Optional Finished Third Floor (Approx. ~~547~~ sq. ft.)

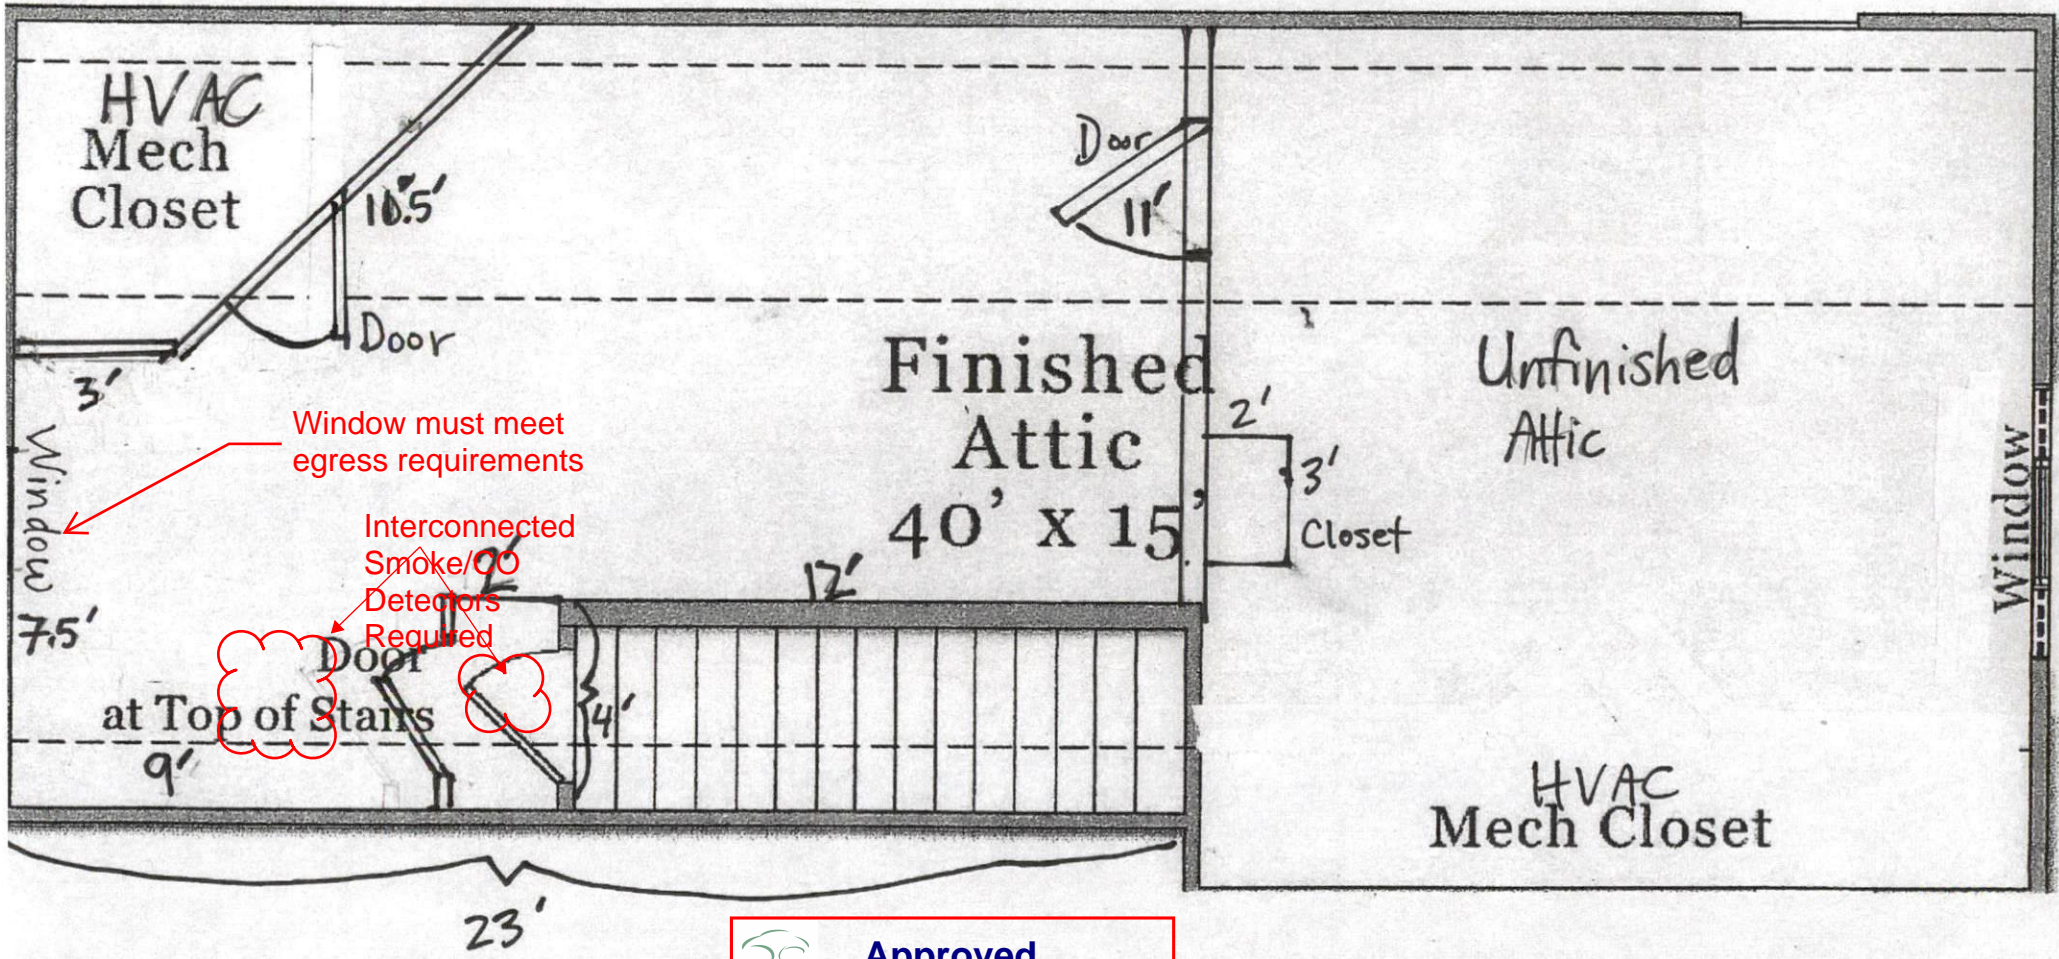
Window must meet egress requirements

Interconnected Smoke/CO Detectors Required
